PLAN COMMISSION STAFF REPORT

Agenda Item: PC Docket No. 20-011

Application Type: **SUBDIVISION – PRELIMINARY PLAT**

Summary: Guy Costanza/GM Contracting requesting approval of a preliminary plat for a one lot commercial subdivision at 407-411 Ridge Road.

Figure 1: Subject property outlined in red.

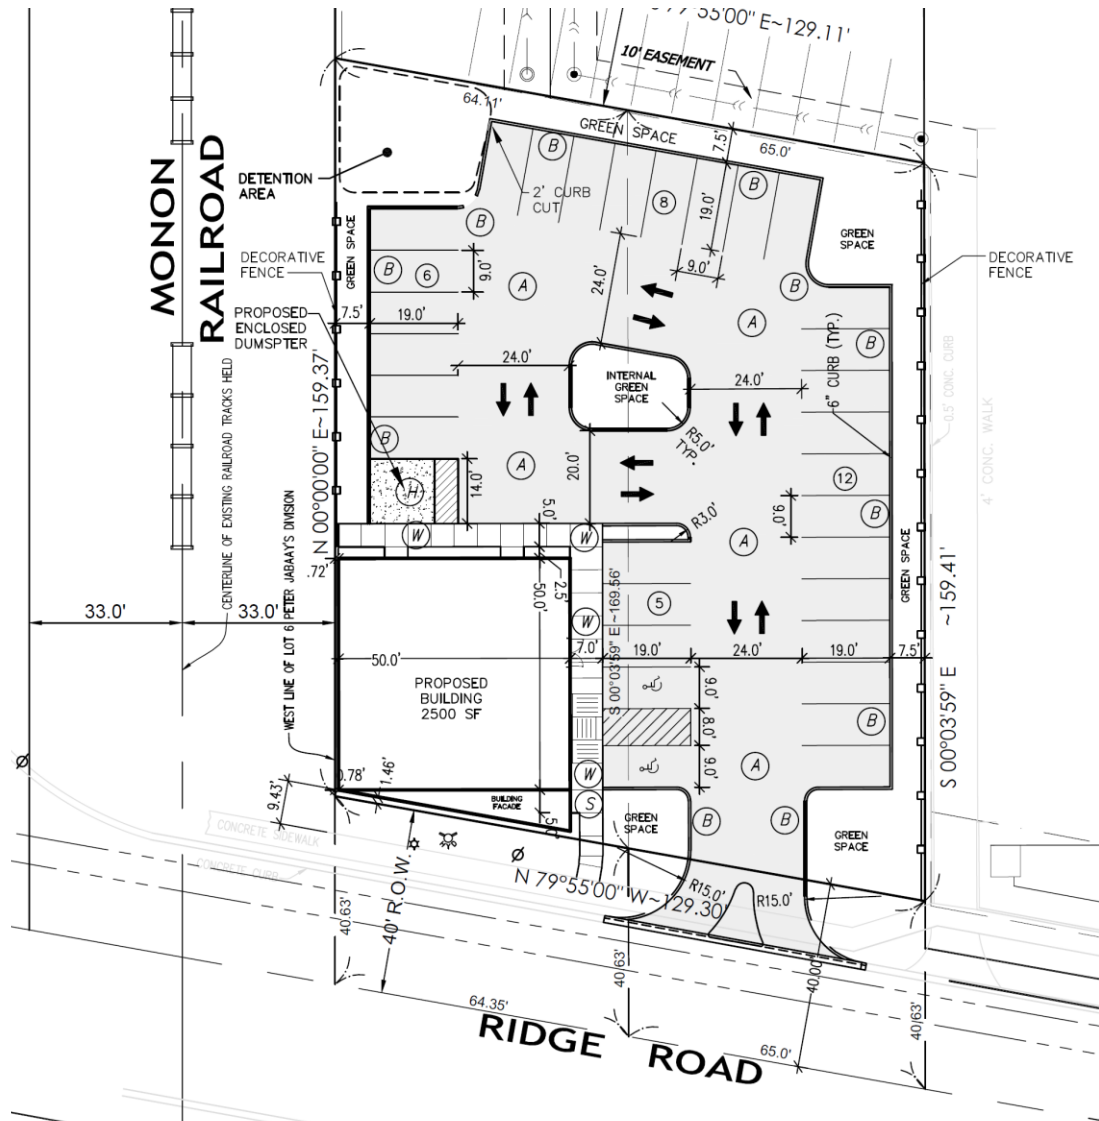
The applicant is proposing an approximately 2500 square foot commercial building with 31 parking spaces and some internal and perimeter landscaping. Stormwater detention is provided in a small detention area in the northwest corner of the parking lot and in the northernmost parking spaces. Access to the lot is provided by a right-in/right-out drive aisle at the southeast corner of the site. Forty feet of right of way for Ridge Road is being dedicated along the south edge of the property.
